STAFF REPORT: 08/13/2025 REGULAR MEETING

APPLICATION NUMBER: HDC2025-00391

ADDRESS: 2255 OAKMAN

SCOPE: REPLACE VINYL WINDOWS

Applicant document and photos.

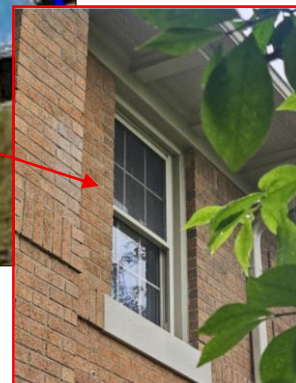
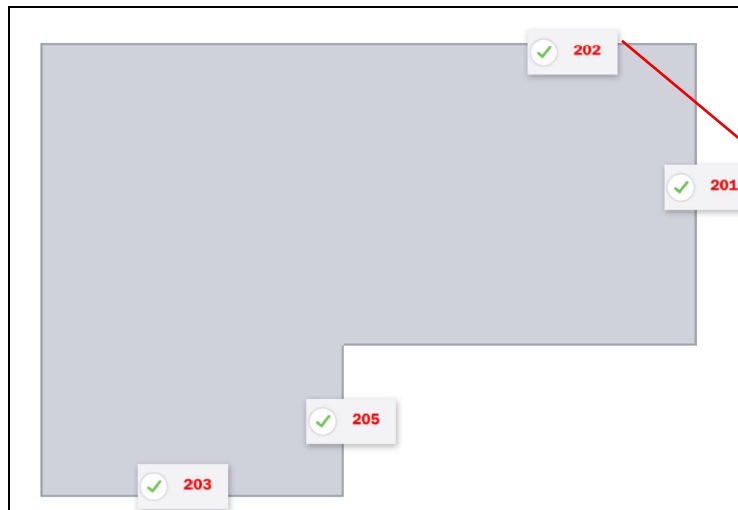
- Staff explained to the applicant, the window contractor, that staff has authority to approve the installation of the windows if they had simulated-divided lites, or “SDLs”. These are grilles/muntin bars that are applied to the exterior pane of glass. However, the property owner requested to keep the proposal for between-the-glass grilles so that the new windows will match the existing vinyl windows which have between-the-glass grilles.

- *Replacing existing incompatible, non-historic windows with similarly incompatible new windows does not meet the Standards.*
- Between-the-glass grilles are flat and obscured by the sheen of the glass. They do not match the profile/dimensionality and appearance of true divided-light historic windows and are not “consistent with the general characteristics of a historic window of the type and period” and are not “compatible with the overall historic character of the building”.

- Regarding the transparency of the selected SmartSun glass, staff isn’t clear on how transparent the selected product is relative to the Low E4 glass option. The applicant submitted completed projects from Detroit’s University District and Palmer Woods (not local historic districts), which he said had Fibrex windows with SmartSun glass installed. The examples offer different effects of transparency. Muirland appears to be a compatible option, while Wellsley, with dark brown frames/grilles (vs. the other house’s brighter tan frames and grilles) does not. Staff has requested glass samples for the Commission’s review at the meeting.

- Installing replacement windows with between-the-glass grilles, which have a flat profile and are obscured by the sheen of the outer glass, do not match the profile/dimensionality and appearance of true divided-light historic windows and are not consistent with the general characteristics of a historic window of the type and period and are not compatible with the overall historic character of the building.
- The transparency of the selected SmartSun glass is in question. Samples of the LowE4 and SmartGlass products are needed.
